Agenda
Village of Arlington Heights
Zoning Board of Appeals
Buechner Room, 1st Floor

Arlington Heights Village Hall
33 S. Arlington Heights Road
Arlington Heights, IL 60005
June 10, 2019
7:00 PM

**Zoning Board of Appeals
6/10/2019**

SHEET NAME:
**FLOOR PLAN &
BUILDING SECTION**
SHEET NUMBER:
1 OF 2

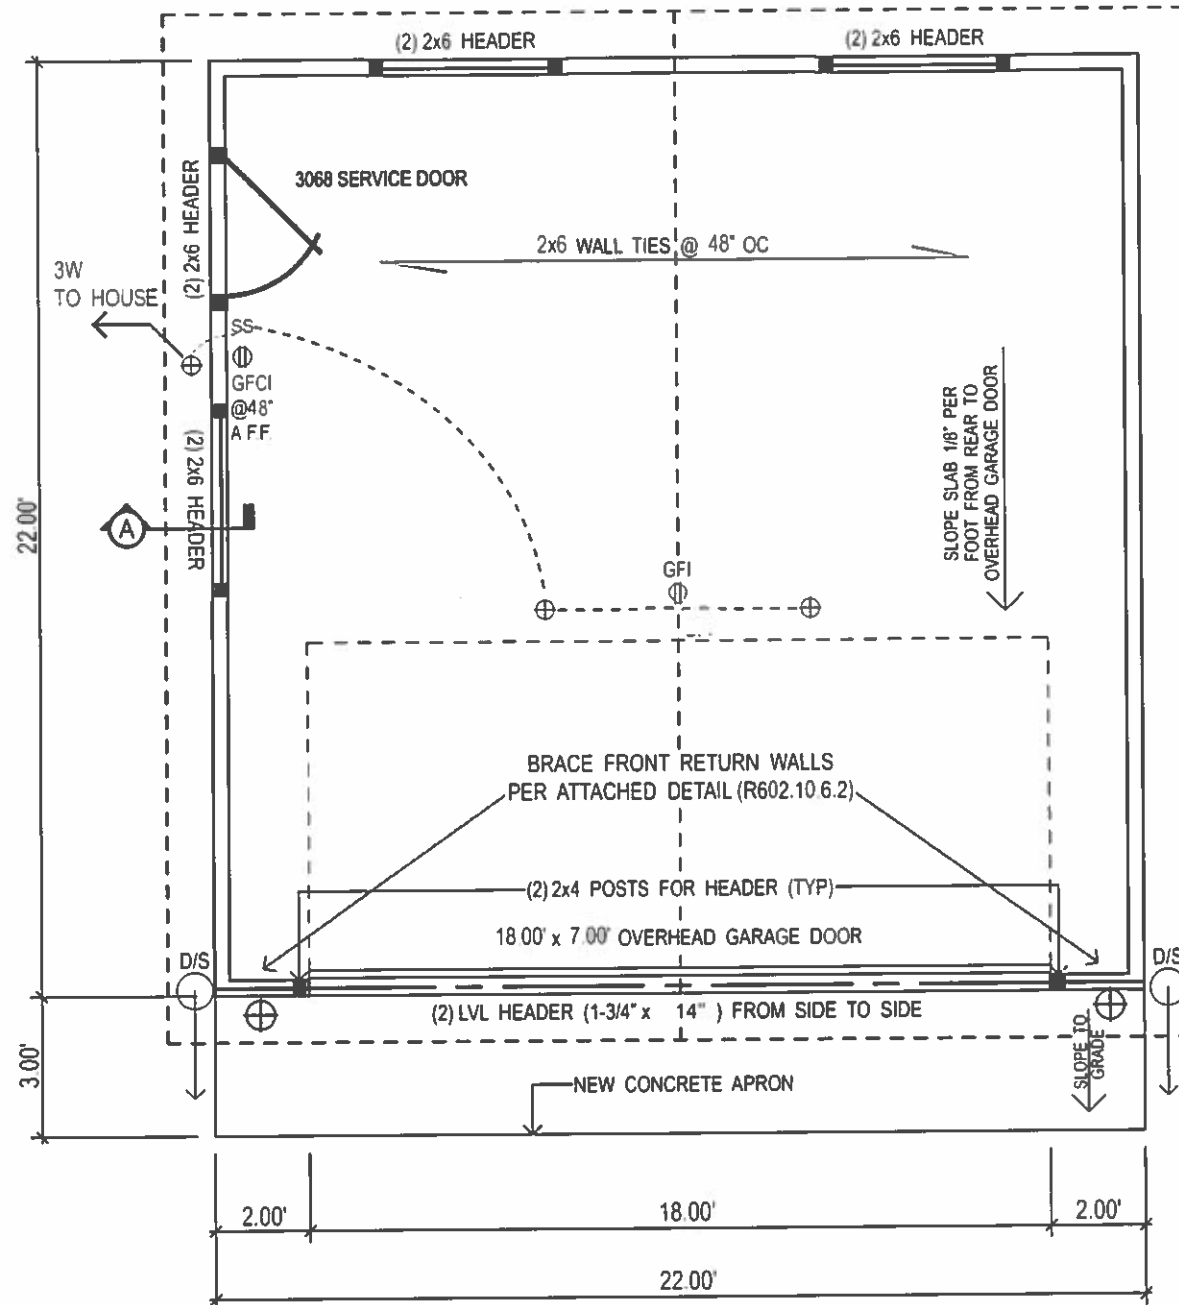
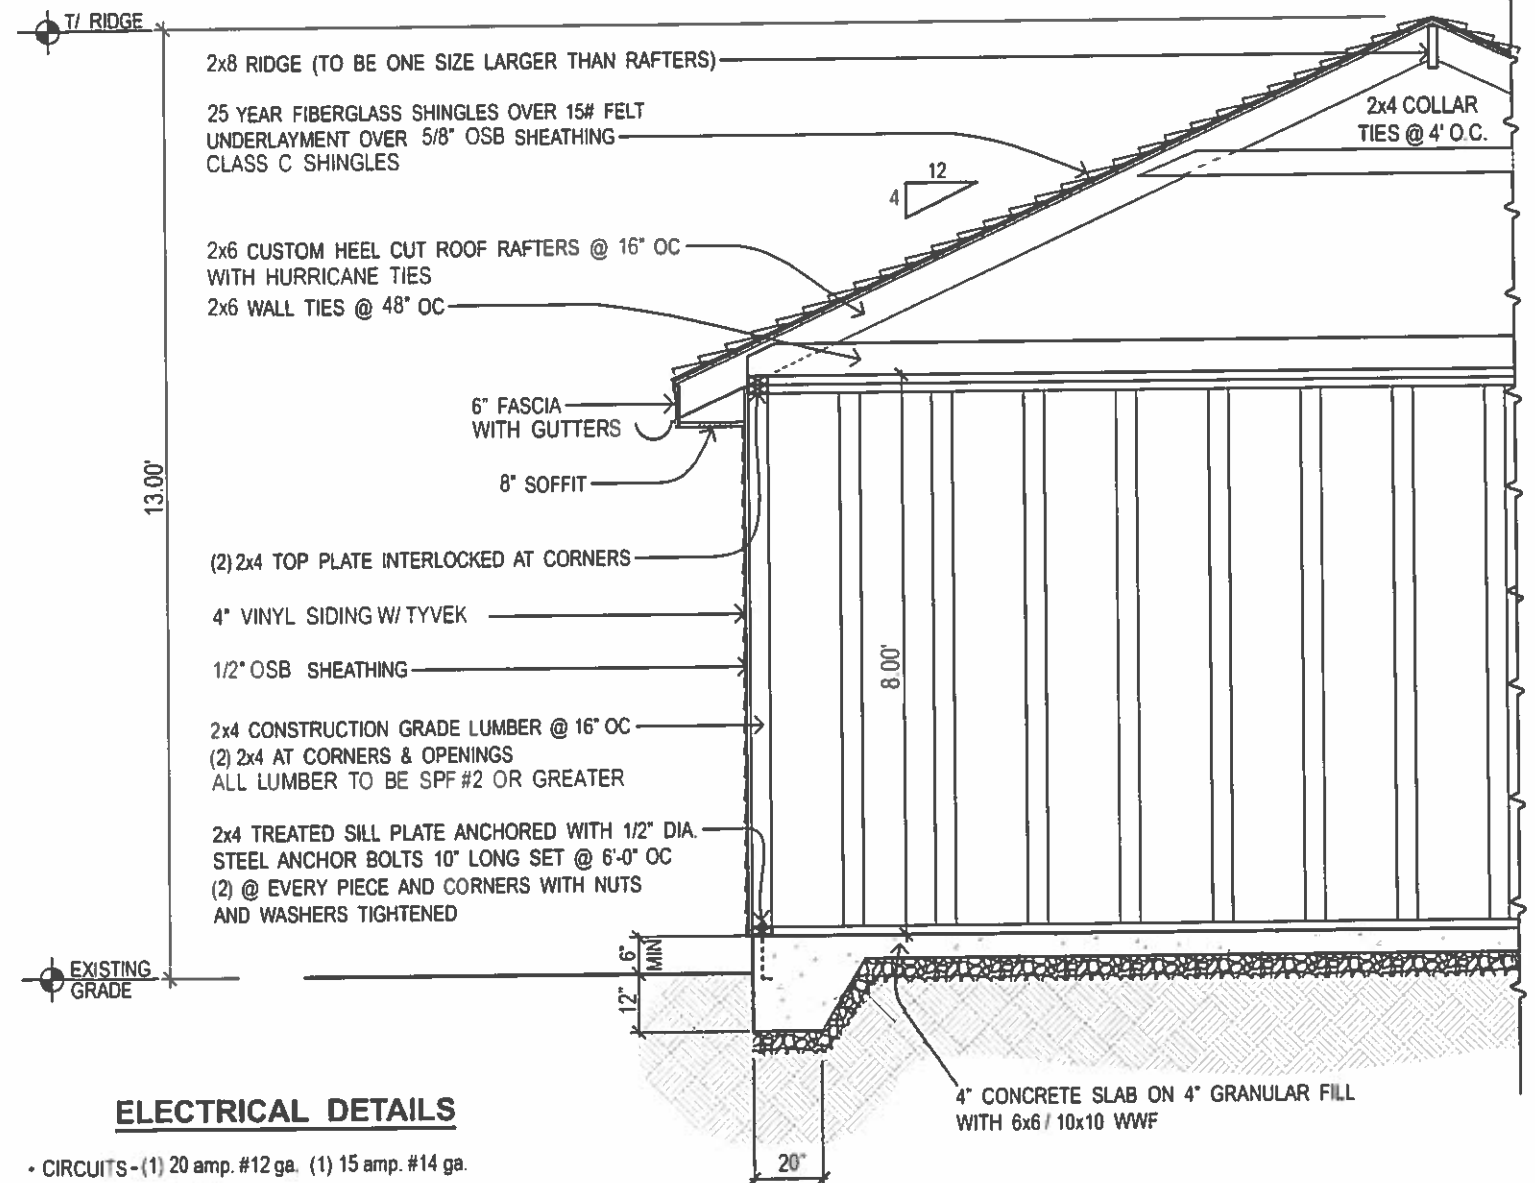
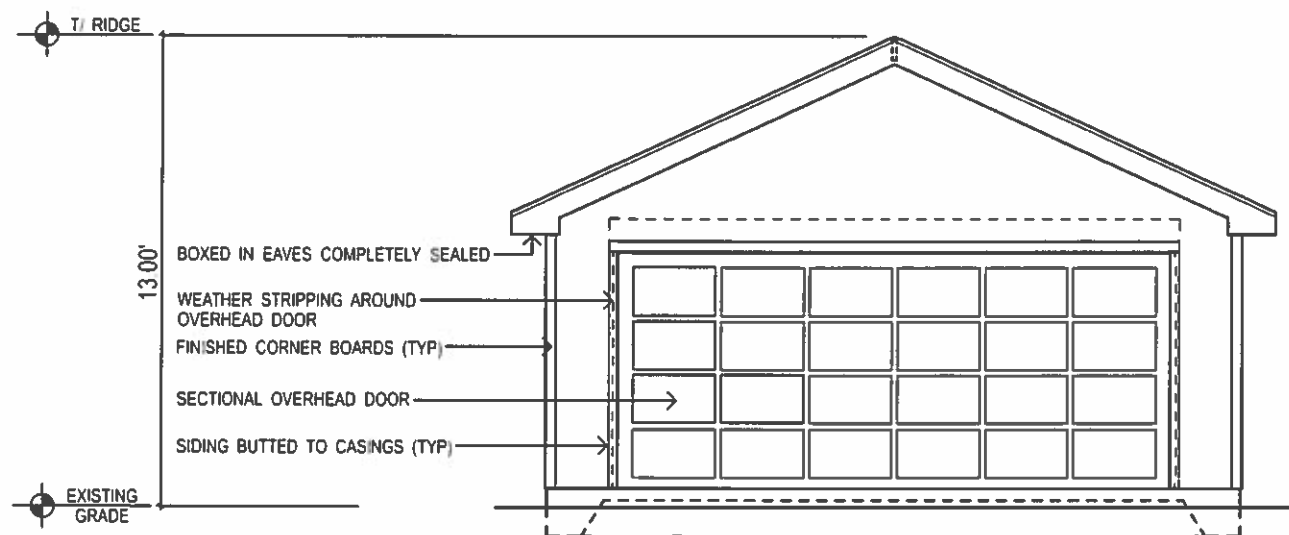
Comments: IT IS RECOMMENDED THAT THE EXTERIOR MATERIALS
AND COLORS BE SELECTED TO MATCH THE EXISTING
HOUSE. - STEVE HAUZINGER, DESIGN PLANNER

PLAT OF SURVEY

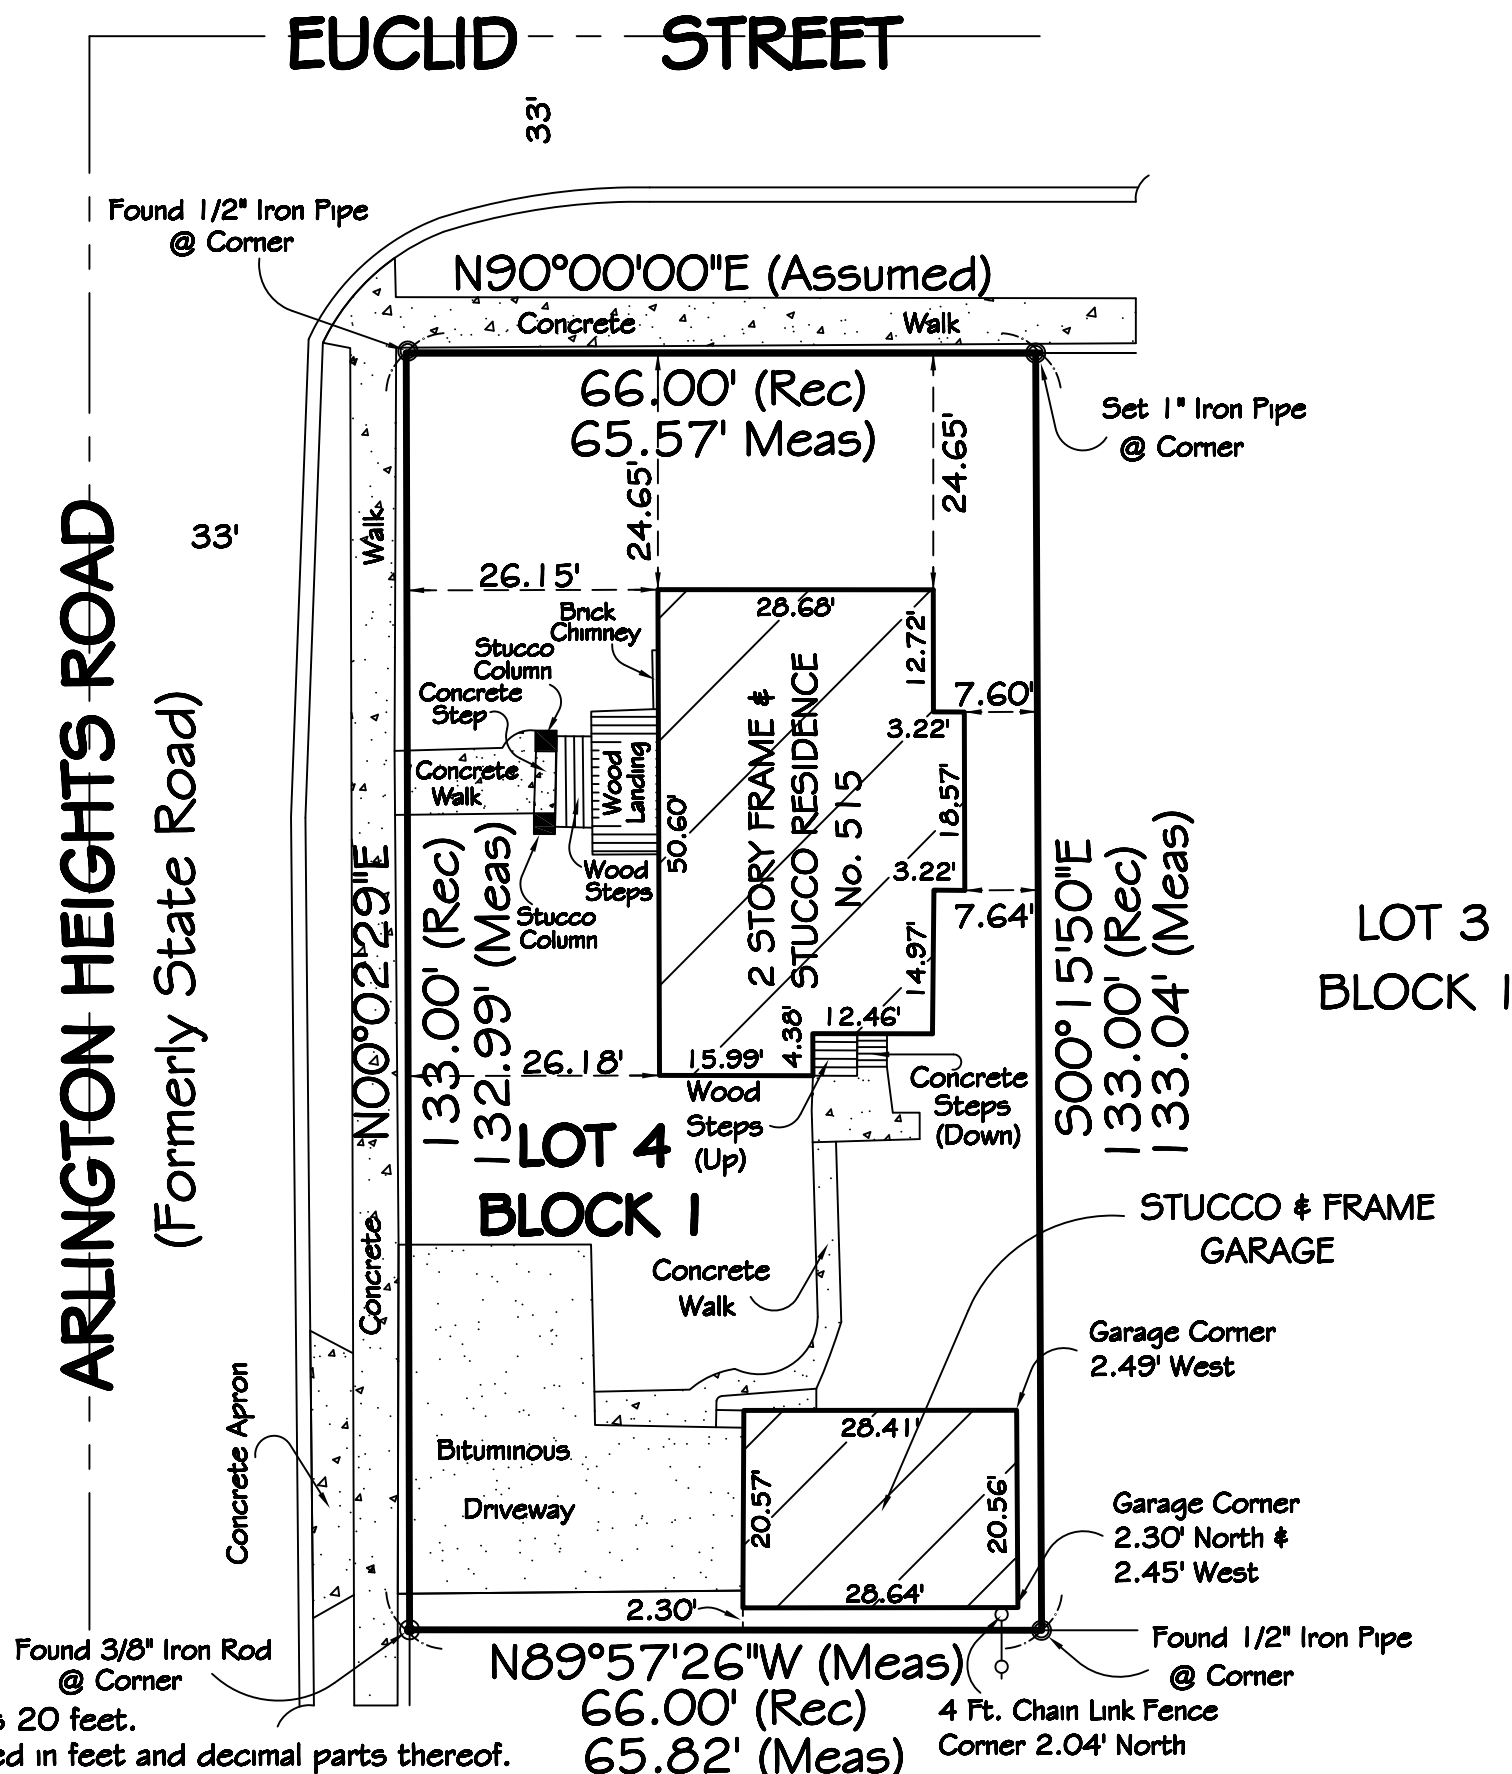
The Engineering Division has NO COMMENT to the proposed variance, however; the deck would be placed over what appears to be a grease trap for the residence. If the grease trap is still in service, access to this structure would need to be provided. This can be addressed at permit.
